Re: Addendum to SWM Report for Draft Plan Approval
Wilder Lake Subdivision
Municipality of Southgate

This letter is provided as an addendum to the Stormwater Management Report that was prepared in November of 2020 to address a few minor requests following the peer review. Peer Review Comments 8 and 16 required minor revisions to the report. The following provides the additional information to confirm the culverts and ditches are sufficiently sized.

REVISED BLOCK 31
 SWM POND

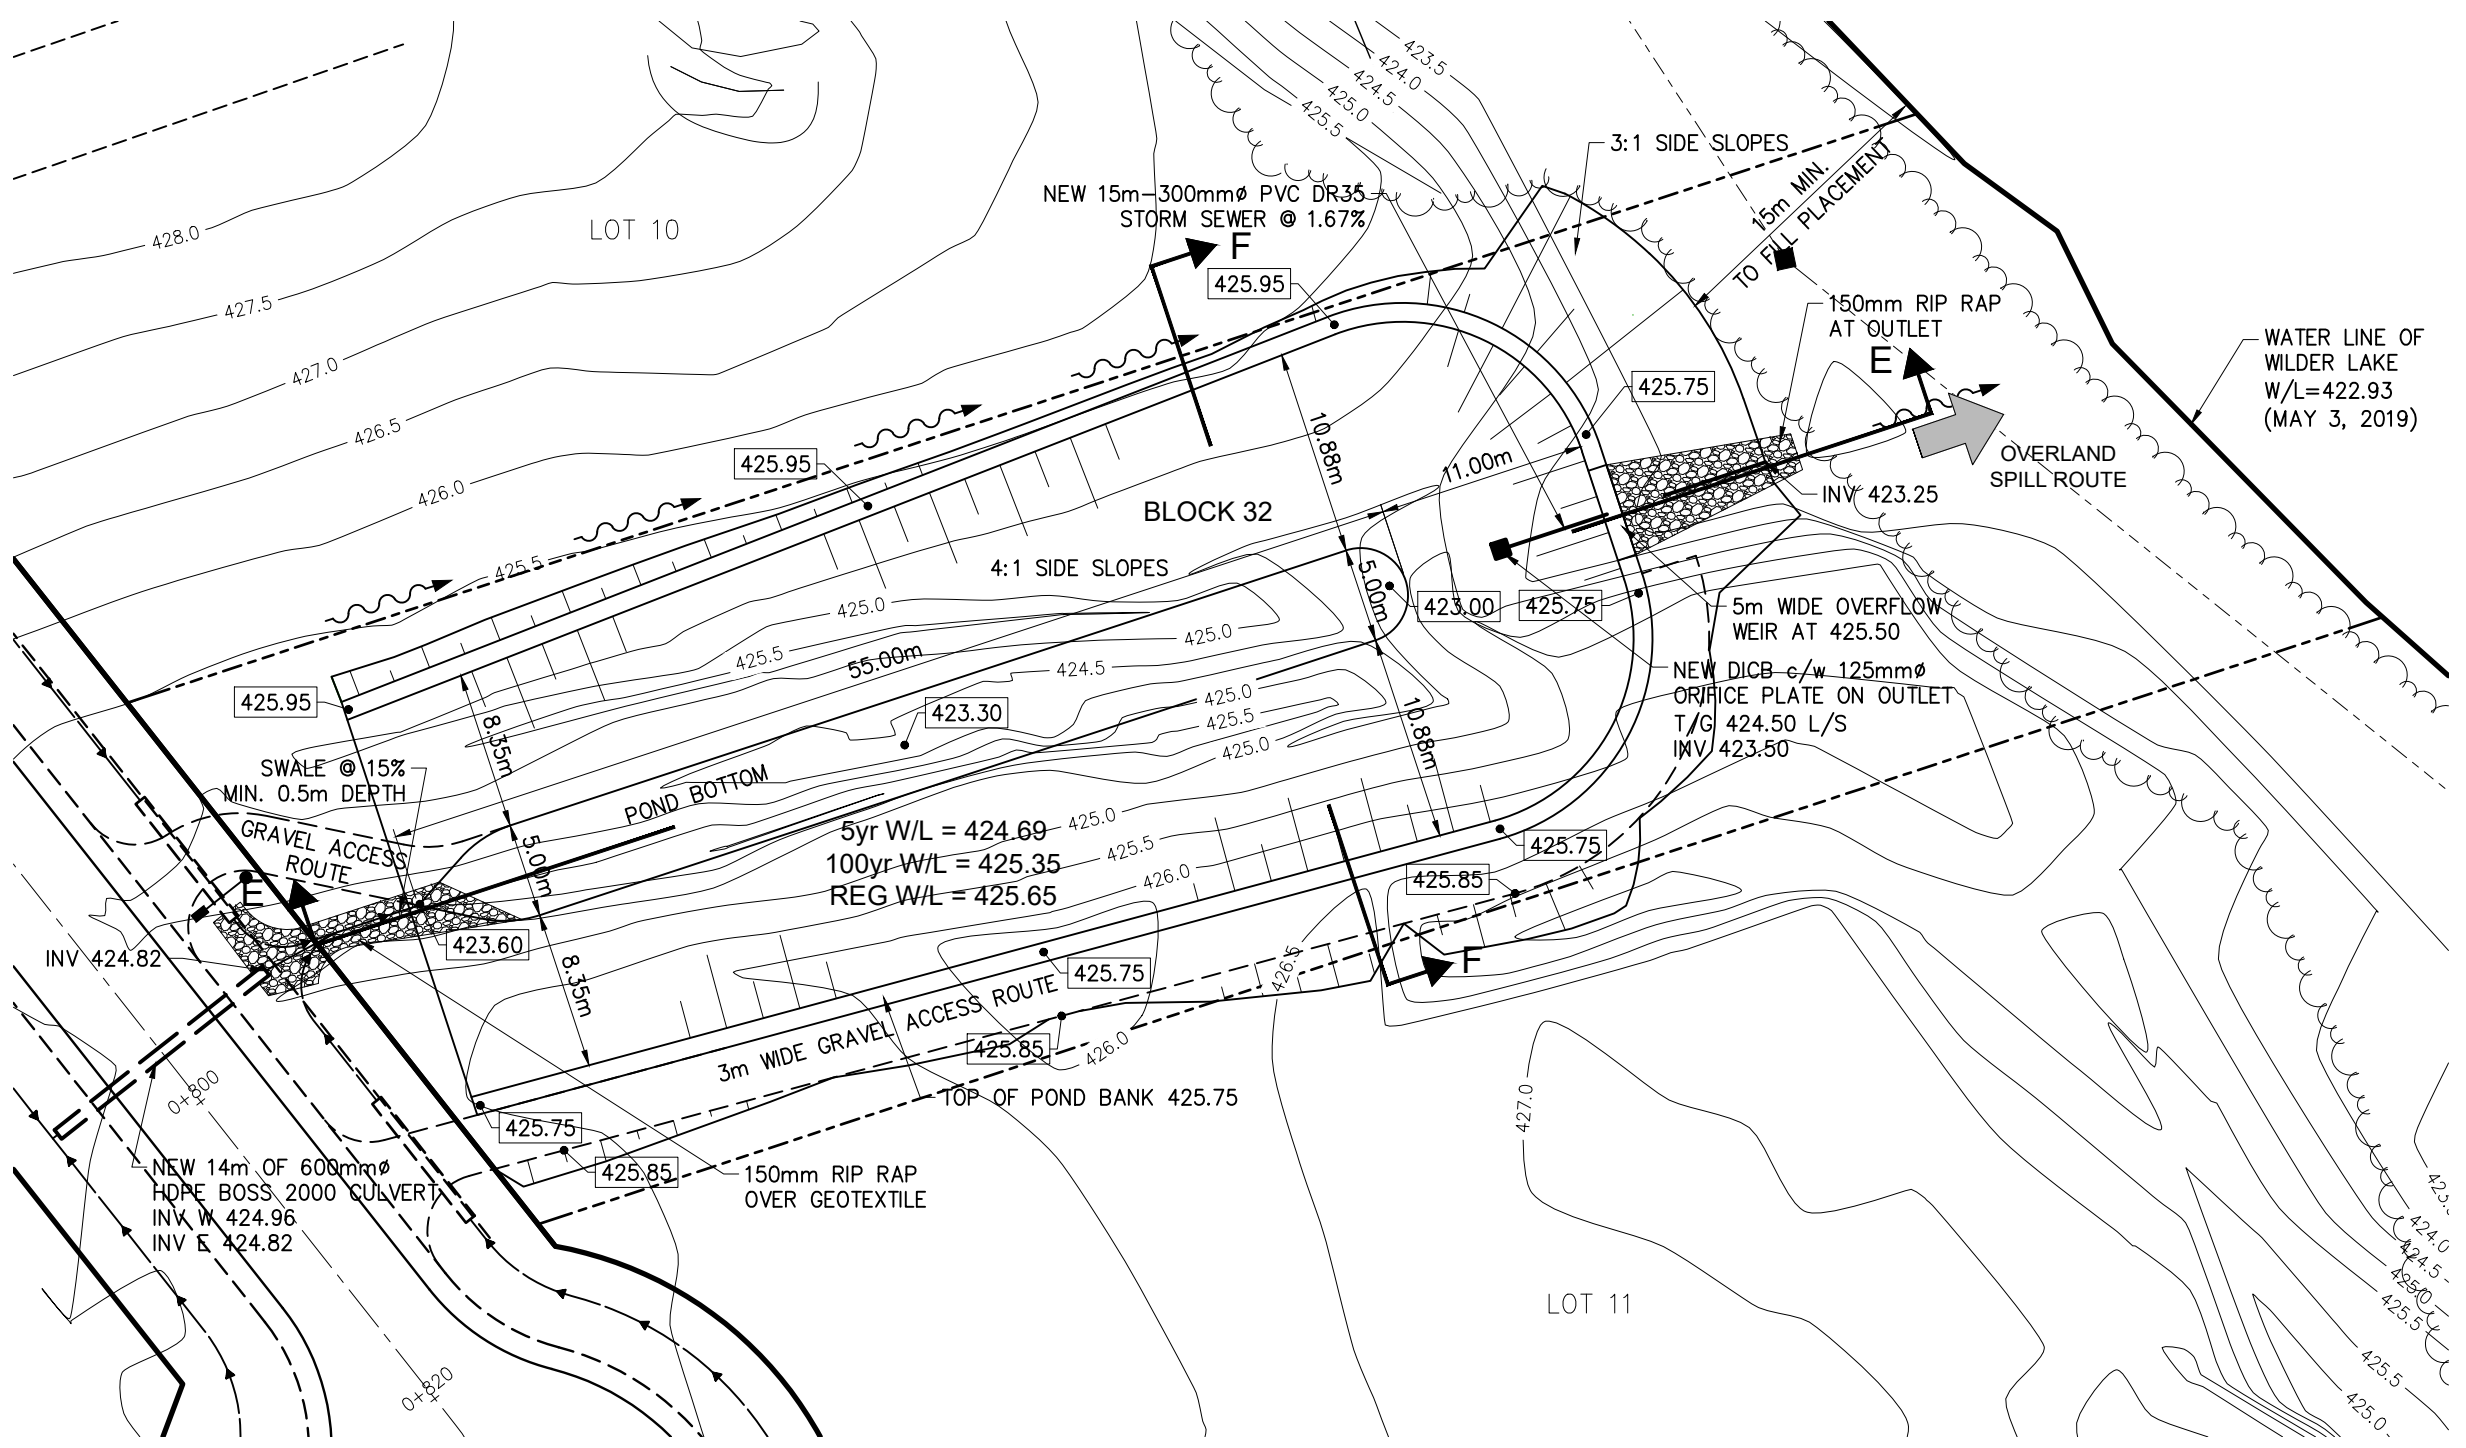
The swale into the Block 31 SWM Pond is very short and very steep with a slope of 8.5%. As shown on the attached Figure 2 which shows the detail for the Block 31 Stormwater Management Pond, a swale with a minimum depth of 0.5 metres and with rip rap leading to the pond, is proposed.

The swale would have the following capacity:

$$Q = (A \cdot R^{2/3} \cdot S^{1/2}) / n$$
$$Q = (0.75 \text{m}^2 \cdot 0.237 \text{m}^{2/3} \cdot 0.150^{1/2}) / 0.025$$
$$Q = 4.45 \text{ m}^3/\text{s}$$

According to the MIDUSS results, during a 100 year design storm, the peak flow rate expected to be directed to the Block 30 SWM Pond would be 0.490 m³/s or 0.692 m³/s during the Hurricane Hazel Flood Event Standard.

As such, the proposed swale has more than sufficient capacity to convey runoff to the SWM Pond.
